1. SUBMITTAL TYPE: (Is this a resubmittal? Yes ☐ No ☒)			
Deferred Submittal ☐	Addendum Number: 01	Revision Number:	CCD Number: Category A ☐ or B ☐
2. PROJECT INFORMATION:			
School District/Owner: San Beranrdo City USD		DSA File Number: 36 H7	
Project Name/School: Indian Springs HS - Health Center		DSA Application Number 04 123900

ADDENDUM NO. 1

Indian Springs High School – Health Center

DSA #04-123900 FILE #36-H7 RCA Project No. 1-78-50

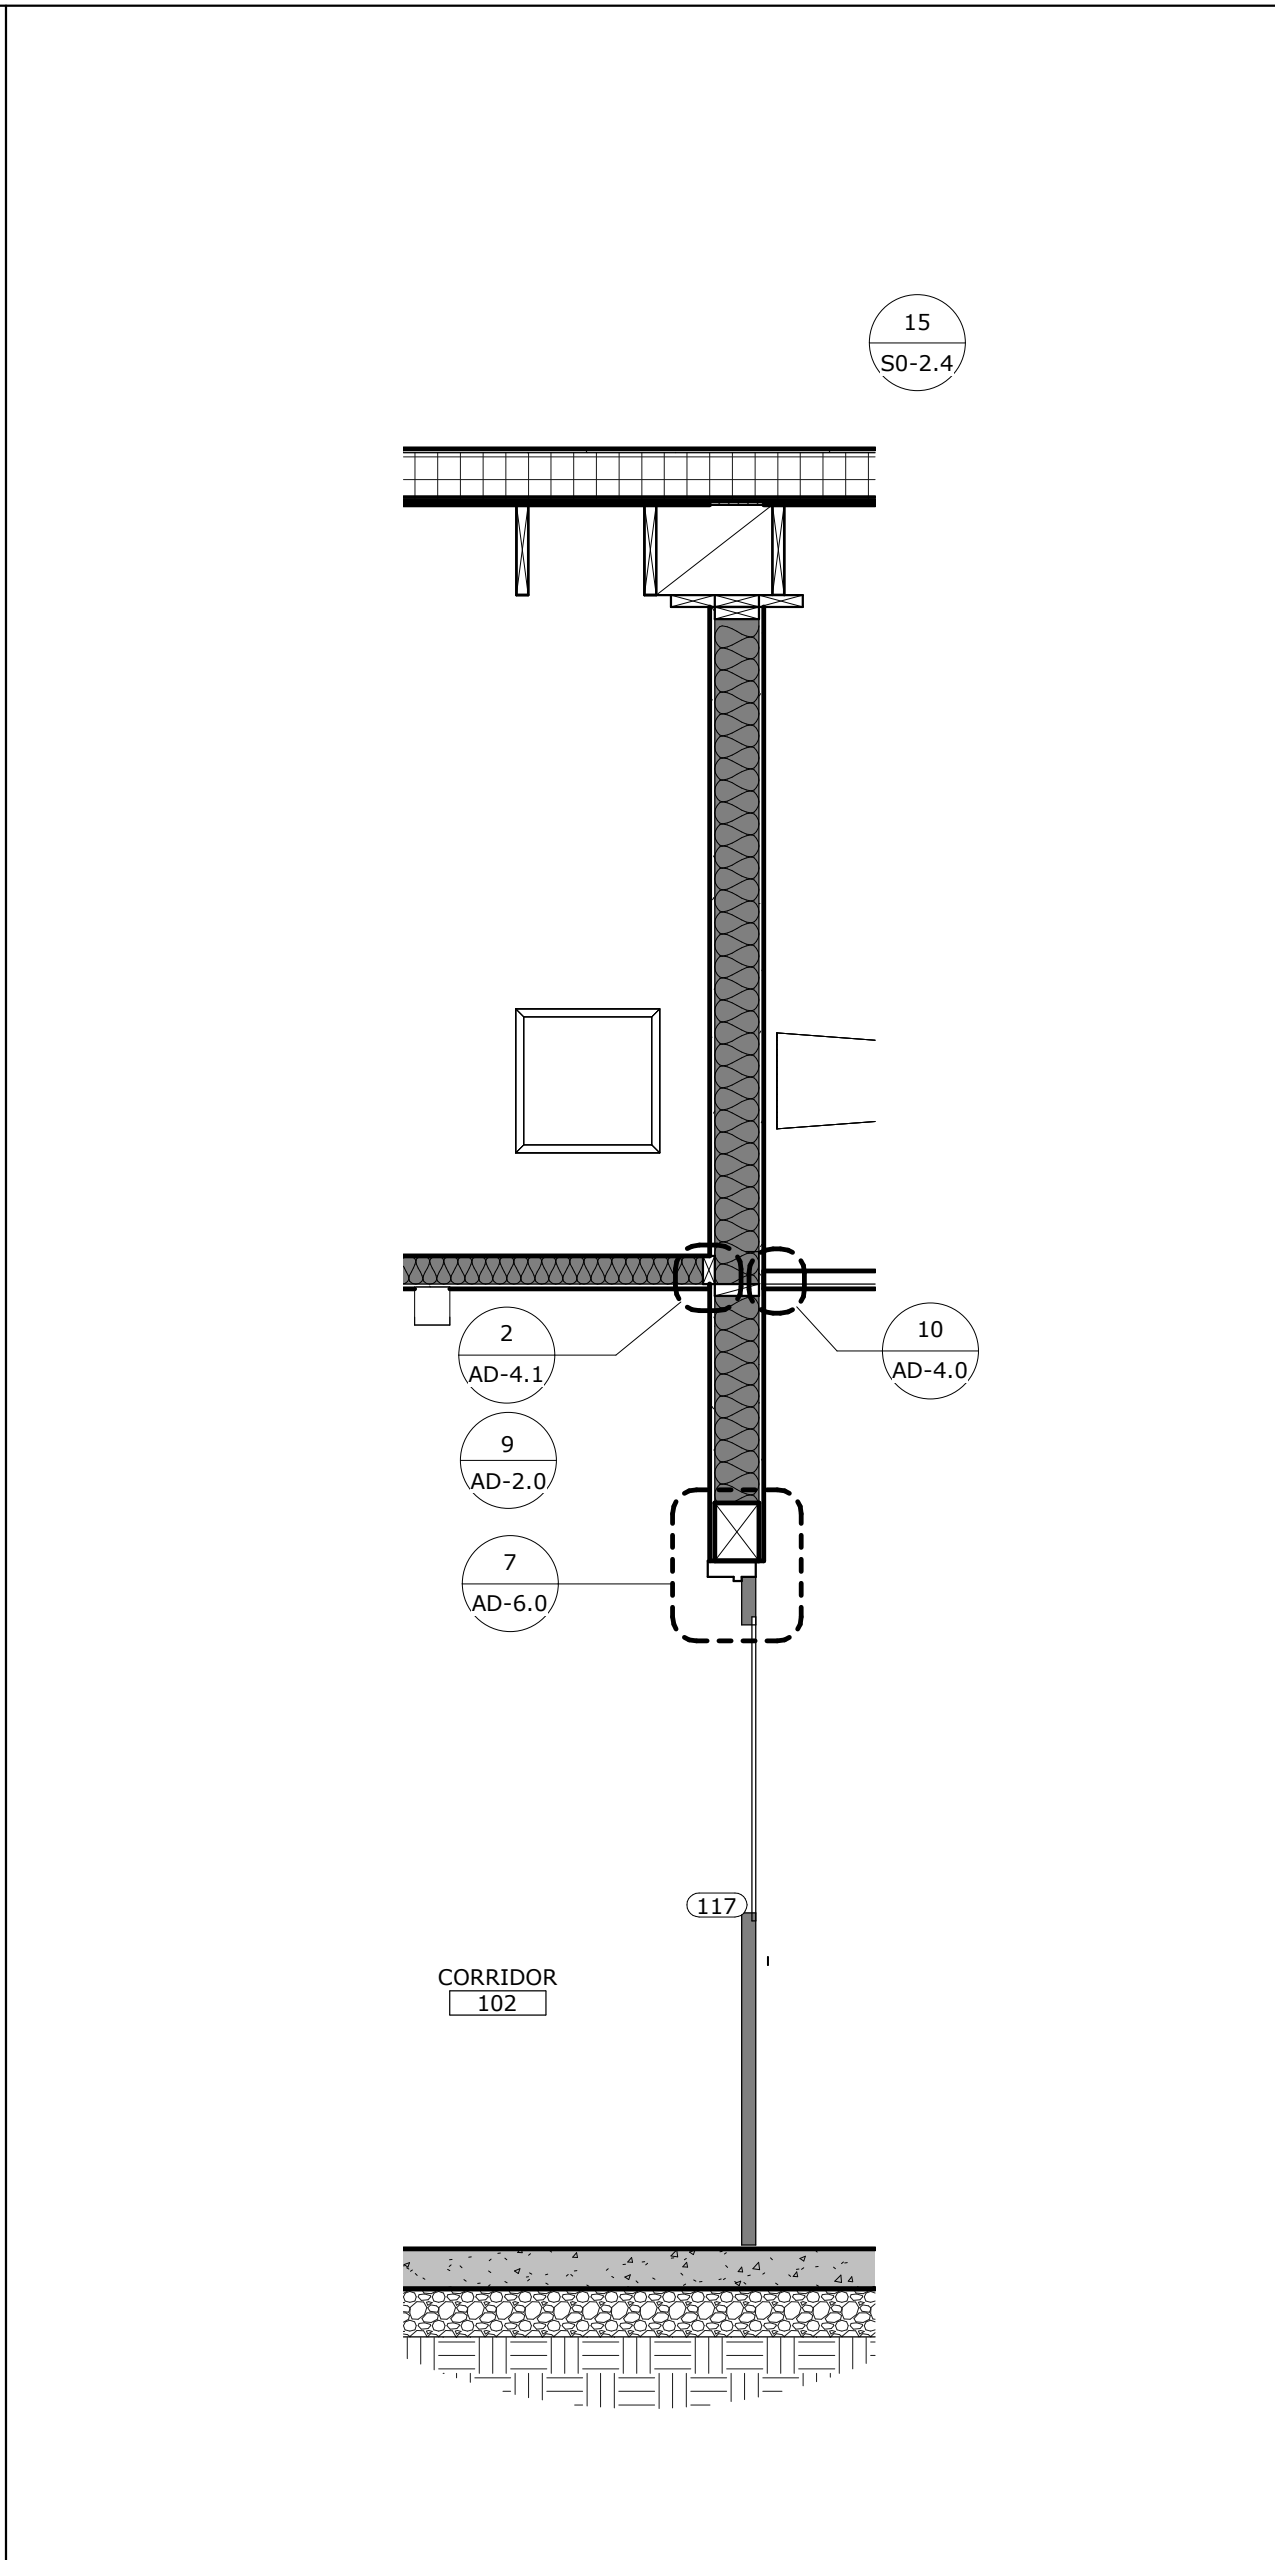
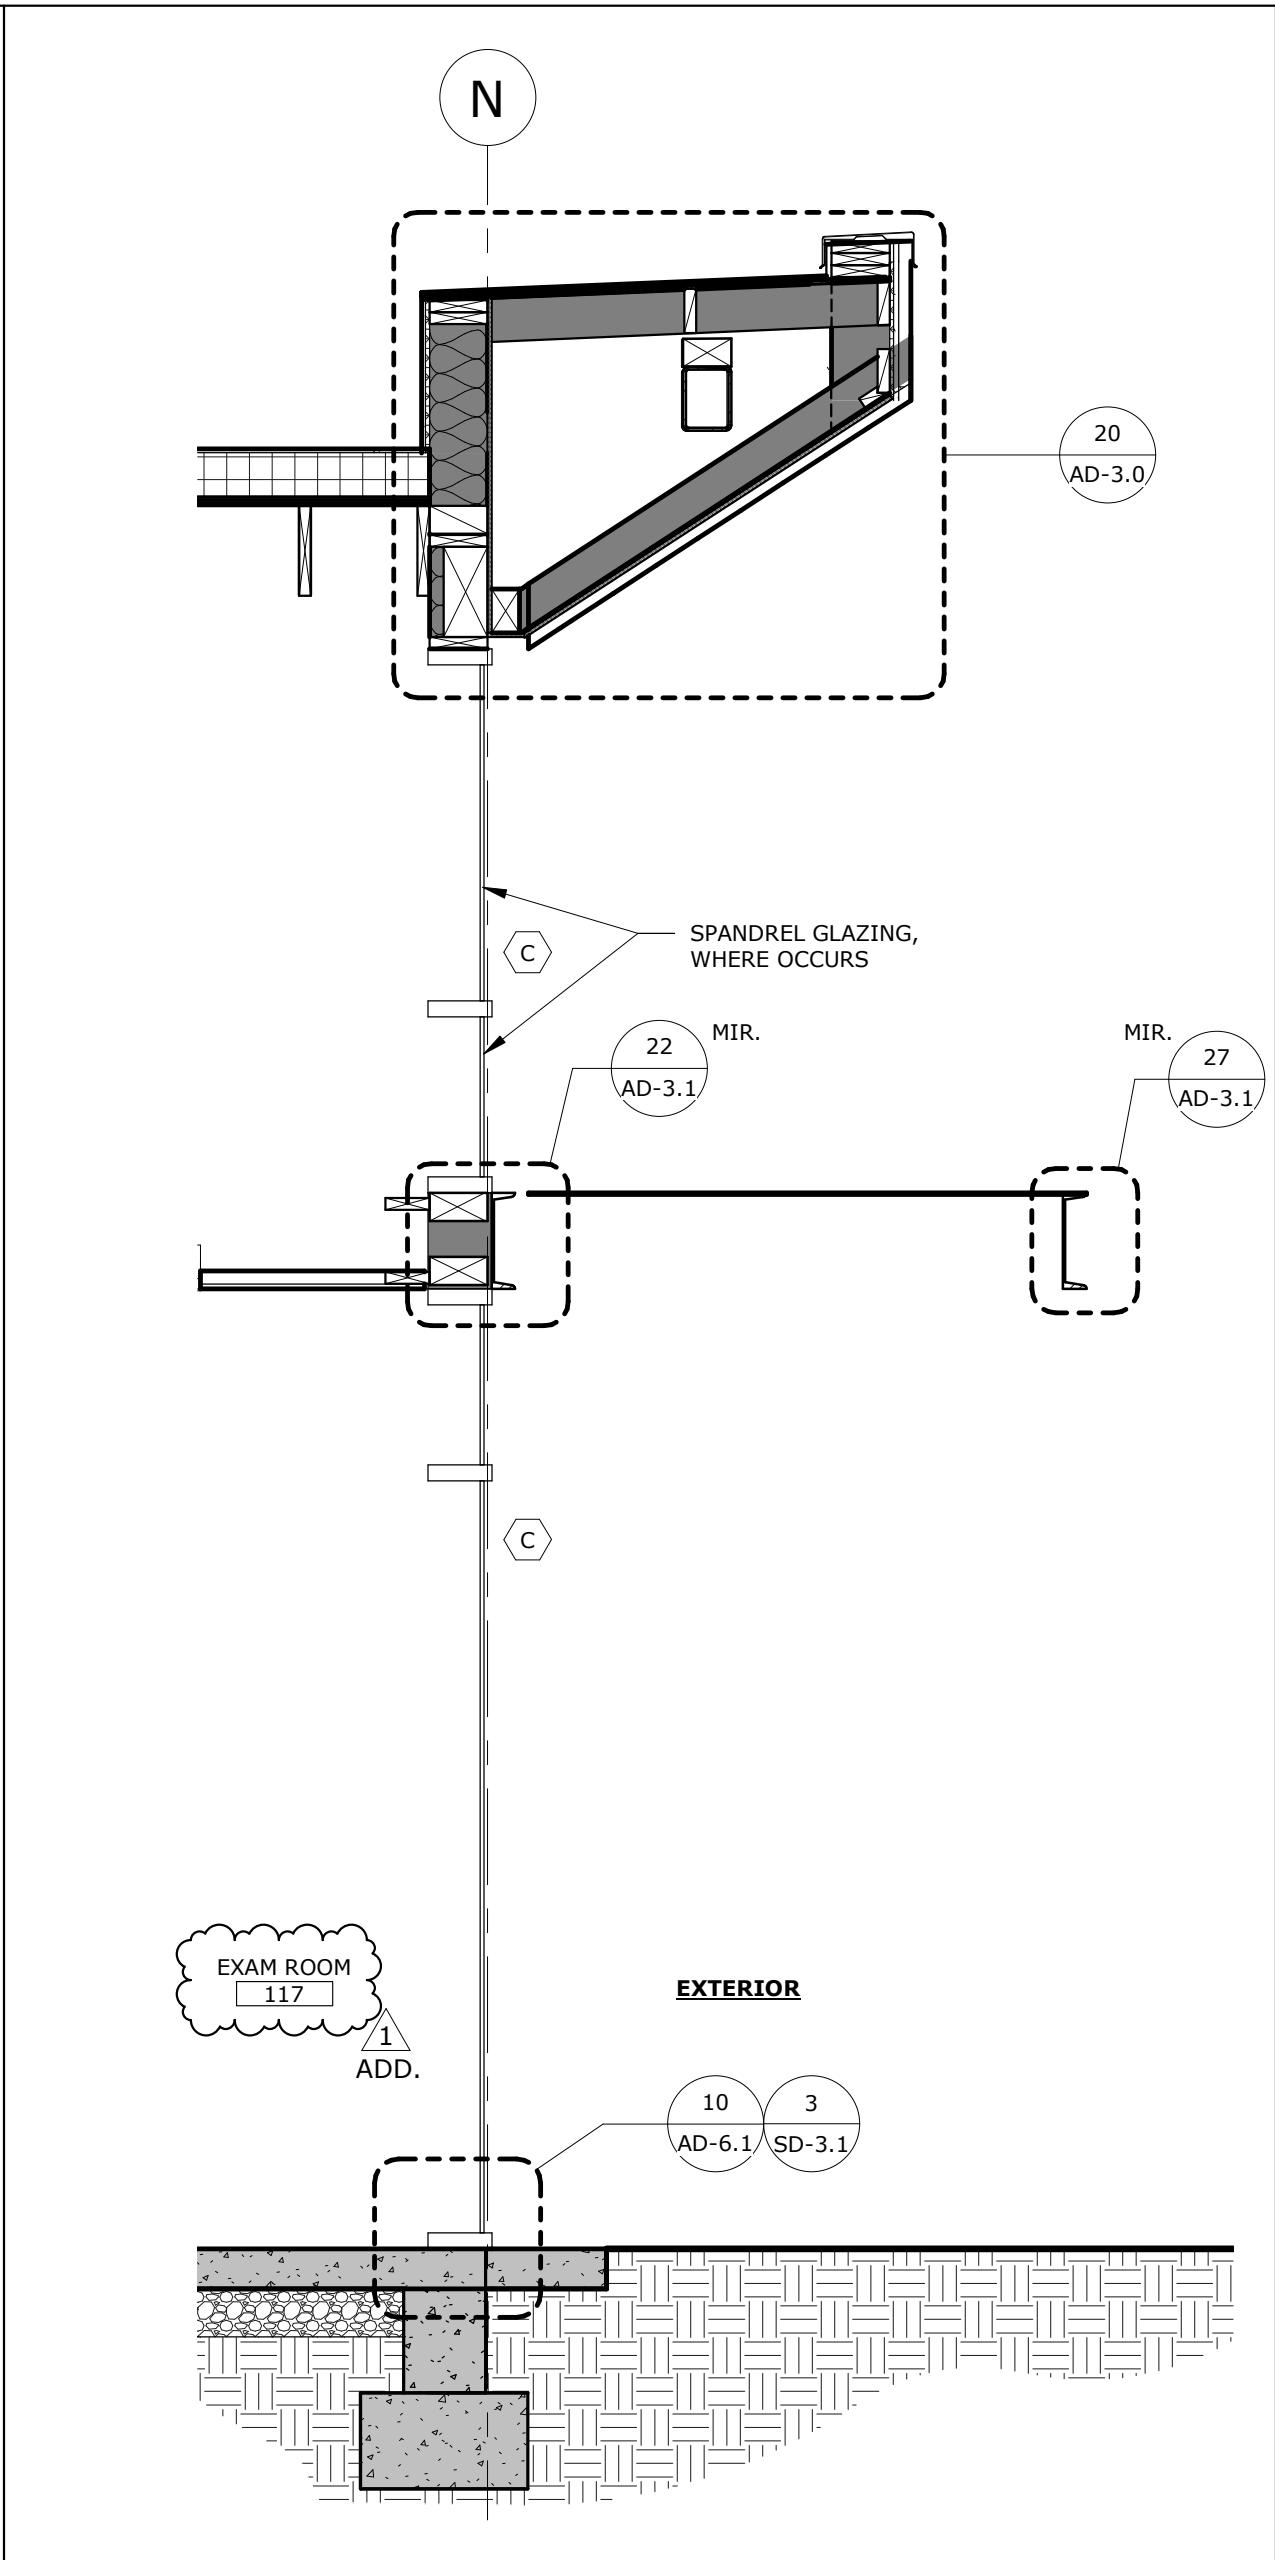
- Item No. 1.13 Reference Sheet A1-6.0 – WALL SECTIONS
1.13.1 Replace Sheet A1-6.0 and revise per clouded areas
- Item No. 1.14 Reference Sheet A1-7.0 – ENLARGED PLANS / INTERIOR ELEVATIONS
